**OLD ORCHARD BEACH
February 2019
PLANNING BOARD
MEMO**

February 2019 Planning Board Memo: Table of Contents

Proposal: Minor Subdivision: 2 Duplex Dwellings with a Total of 4 Residential Units
Action: Ruling on Preliminary Plan, Ruling on Final Plan
Owner: Donald Bouchard
Location: 189 Saco Avenue, MBL: 208-3-12

Figure 1: New Proposal (January 2019)

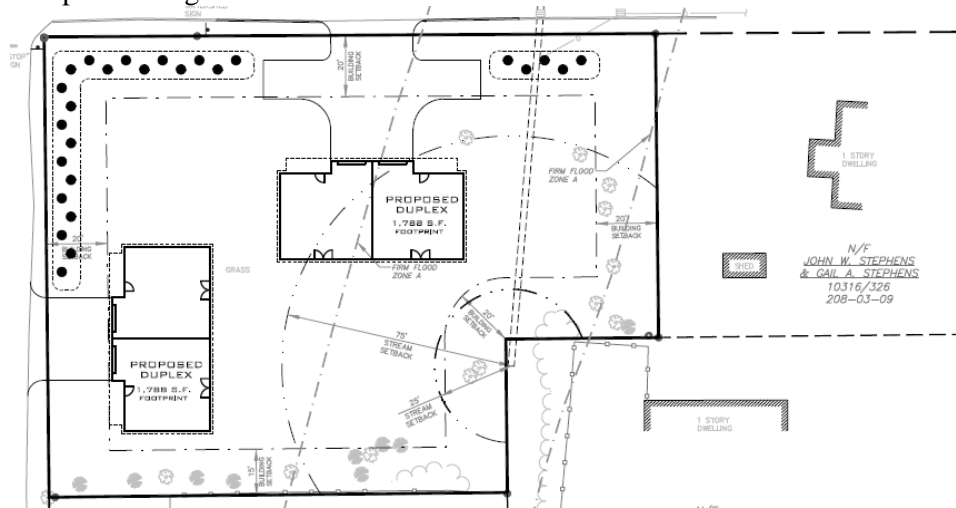
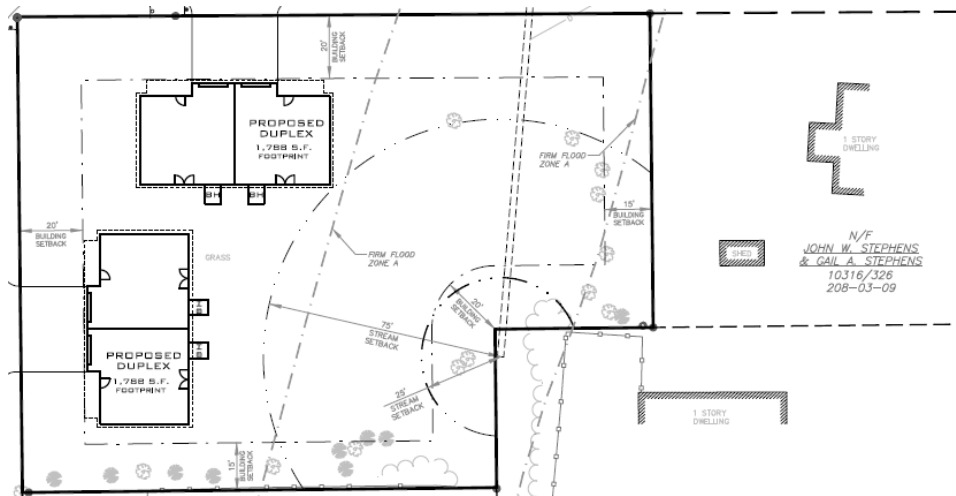
One of the primary concerns was regarding parking, Sec. 78-806(a)(1) of the ordinance states no parking shall be permitted in the front setback yard. The duplex on Macarthur Avenue still included parking in the front setback. No provisions appeared to exist for a driveway exemption of waiver so Planning Staff recommended the Applicant apply for a variance through the ZBA. The Applicant went before the ZBA on January 28th and the decision was tabled. Without the variance, this Applicant cannot receive final plan approval from the Planning Board.

Regarding setbacks, the rear lot line for a corner lot is the line opposite the front lot line of least dimension. In this case, the front lot line of least dimension is the one abutting Macarthur Ave. So, the rear lot line is towards the eastern portion of the property, adjacent to the Stephens and Joncas properties. GB1 requires a 20' rear setback for residential lots. The plan shows a 15' setback abutting the Stephens property. Plans should be amended to show a 20' setback. Note: this does not impact building location.

Regarding parking, 78-806 (a) (1) states no parking shall be permitted in the front setback yard. Both duplex's show driveways in the front setback which makes it reasonable to assume parking will be in the front setback. Staff understands the need for this standard but it's a bit hard to digest regarding residential driveways. Nonetheless, we are not aware of a driveway exemption or waiver. This will require additional thought. Note: building relocation (e.g., further into the lot to allow for parking out of the setback) will be difficult due to the location of the 75' stream setback and floodplain.

Sec. 78-1466(c) of the ordinance requires 257 feet of sight distance on Macarthur and 308 feet on Saco Ave. Do the driveways meet these? Planning staff did not see sight distances listed on the plan. The ordinance also says a driveway cannot be within 50 feet of the curblin tangent of intersection local streets. The distance from the driveway coming off of Saco Ave and Macarthur should be measured in relation to their distance to the intersection. Does it meet or exceed 50 feet? One concern about site distance is the proposed buffer location. We'll need more info on this.

Secs 78-1821 – 1827 regulate screening and buffering. The plans show a proposed vegetative buffer along both street frontages. The southern and at least part of the eastern appear (based on aerials) to have an existing buffer. The applicant should demonstrate how the proposal complies with 78-1821 – 1827.

- Sheet 3 of 8 shows a CB located over the existing 36-in pipe, the invert in is lower than the invert out is that right?
- Sheet 4 of 8 shows a row of arborvitae along corner of MacArthur and Saco Ave – sight distance with this at the intersection and access to Saco Ave?

The Applicant has decided to rework the plan so that they do not require a variance from the ZBA. They have requested the application be tabled at the February meeting.

We recommend the Planning Board table the proposal until the Applicant brings back the revised plan (likely in March).
